December 1, 2017

**Re: Response to WDNR Questions Regarding the Supplemental Site Investigation Report  
Former Hoffman's Valet Cleaners  
7215 W. Center Street  
Wauwatosa, Wisconsin 53210  
BRRTS# 02-41-307576  
FID# 241083150**

**SITE LAYOUT AND CROSS-SECTION TRANSECT MAP**  
 Former Hoffman's Valet Cleaners  
 7215 W. Center Street  
 Wauwatosa, WI

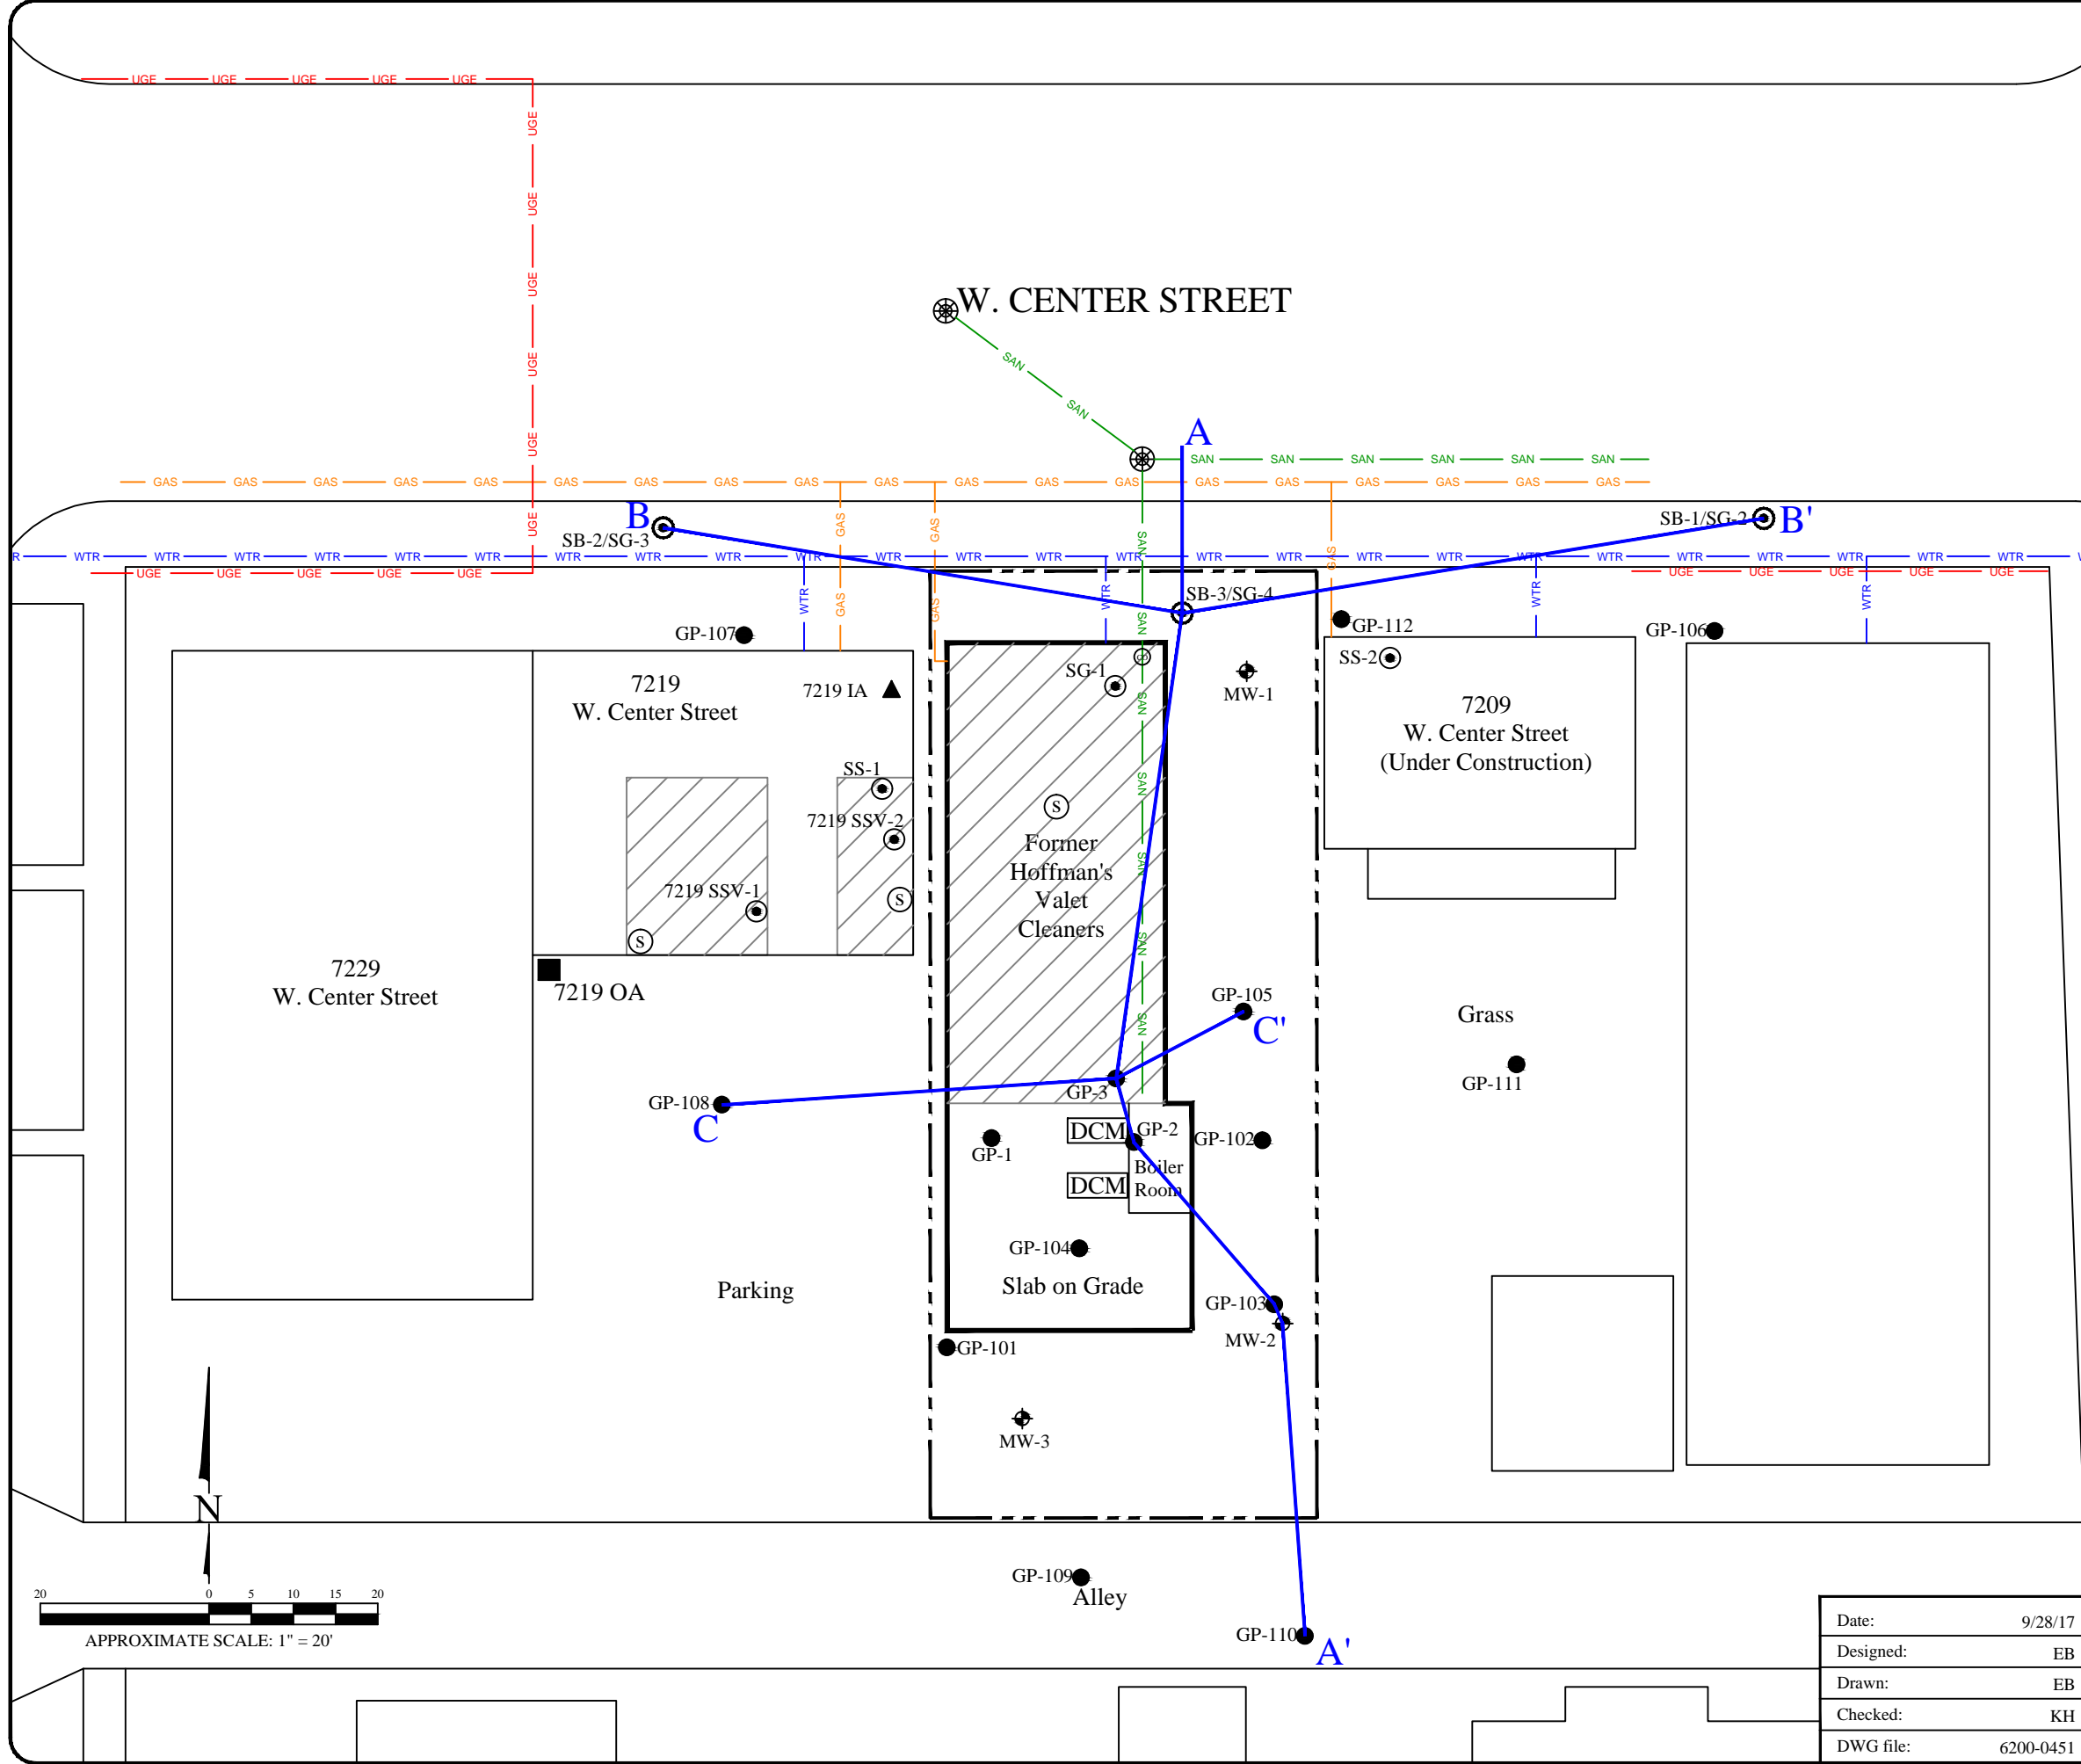
- a. The dry cleaning machine must be included on all maps.**
- b. The industrial and nonindustrial soil RCLs were updated in March 2017. All soil analytical tables must reflect current standards.**
- c. Groundwater Sample Analytical Results Figure 6 must include an isoconcentration line or lines that reflect the areal extent of the groundwater contamination plume.**

- 5.a.** Report figures in **Attachment 1** have been revised as appropriate to show the locations of the dry cleaning machines. They are situated in the south part of the building which is slab on grade.. According to the owner, Ms. Natalia Berdnikova, dry cleaning machine #1 is no longer used.
- 5.b.** **Table 2** in **Attachment 2** has been revised to reflect the new soil standards.
- 5.c.** **Figure 6** has been updated to show the estimated extent of PCE above ES standards and above PAL standards.

### SOIL GAS AND VAPOR INTRUSION ASSESSMENT RESULTS

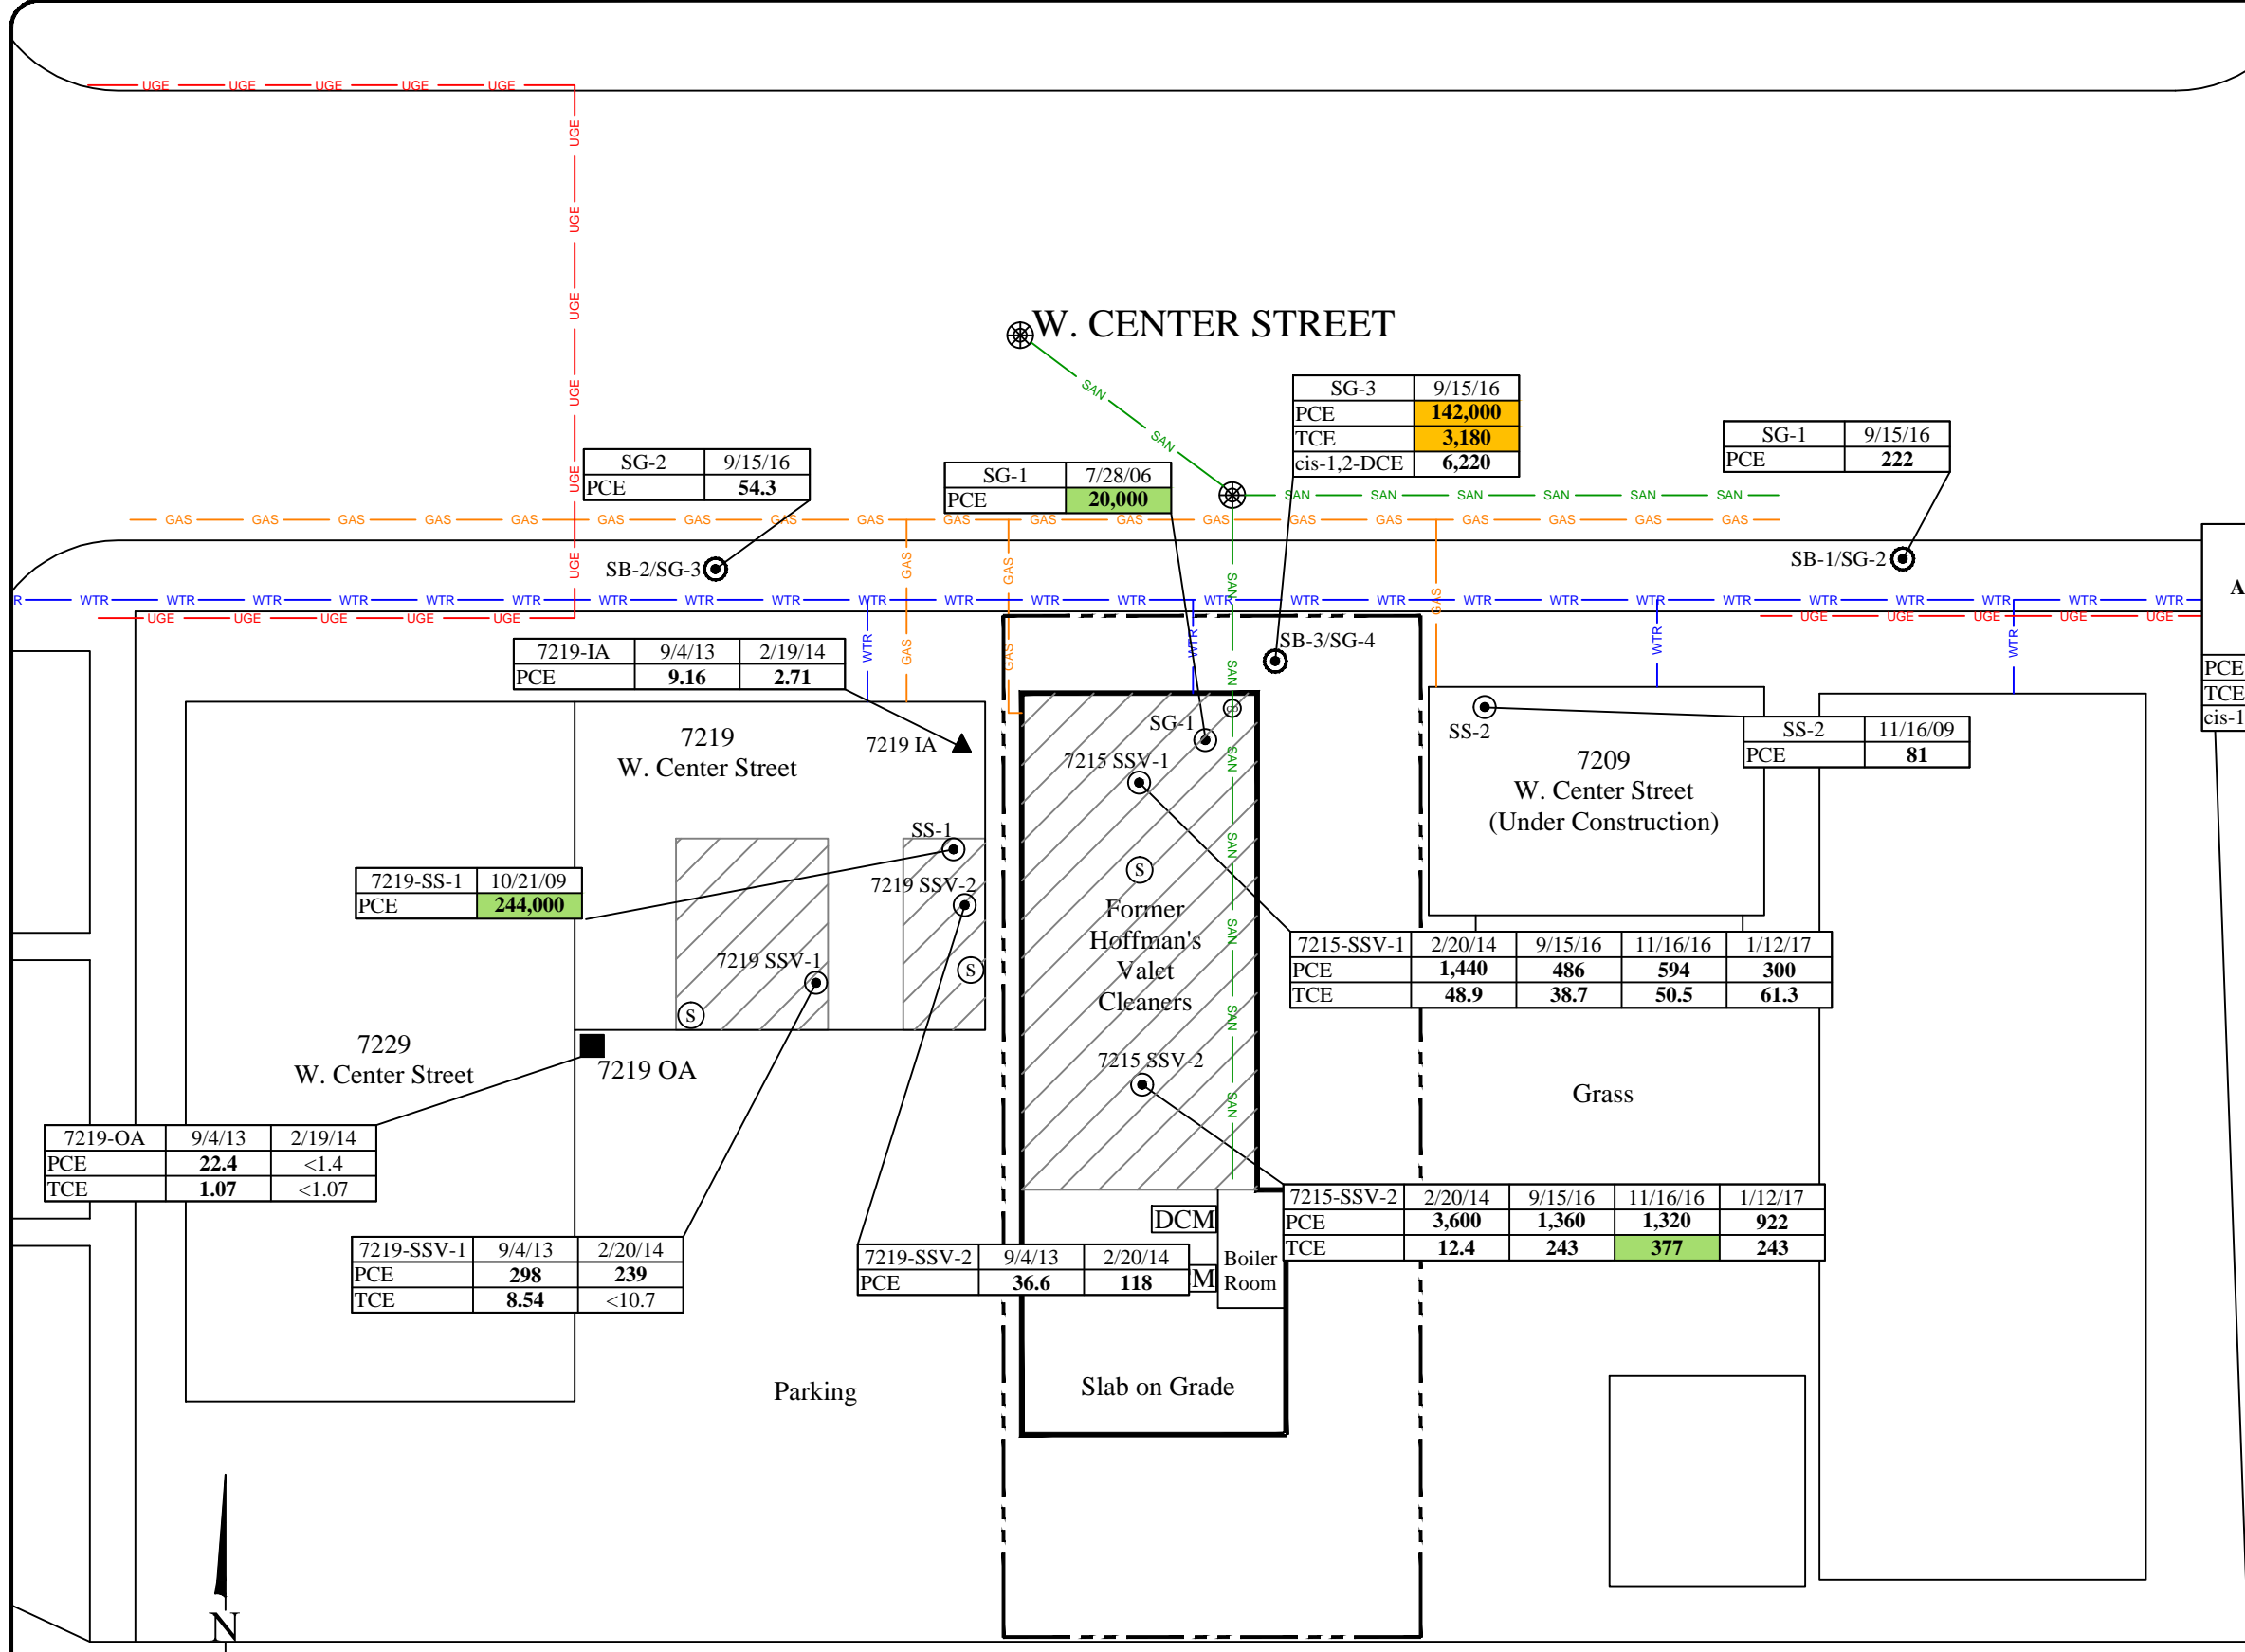
- a. **Discuss in more detail the results of the soil gas sampling in the right-of-way (ROW) relative to the depths of the utility lines. If there is a potential pathway for further migration along the utility lines, then assess the potential effect on offsite properties. This may result in additional vapor sampling.**

**3.a.** Vapor samples were collected from near the water main both east and west of the site for subsurface vapor screening purposes as shown on **Figures 2, 5, 7, and 8**. An additional vapor sample was collected near where the sanitary lateral enters the site building. Soil samples were also collected at all of these locations. As shown on attached **Figure 8**, the natural gas service is located at 3.6 feet below ground surface (bgs) and the storm sewer service is 4.8 feet bgs. As shown on **Figure 9**, these two utilities would be expected to be located above the sand seams identified near MW-1. The water service and sanitary sewer lateral are located at a depth of 7.0 feet and 9.0 feet bgs, respectively. These two utilities were suspected as potential vapor migration pathways. All utilities are located above the water table, which exists at this location in the clayey soil at a depth of approximately 14 feet bgs, and as such the utilities are not expected to be conduits for the migration of groundwater impacts.
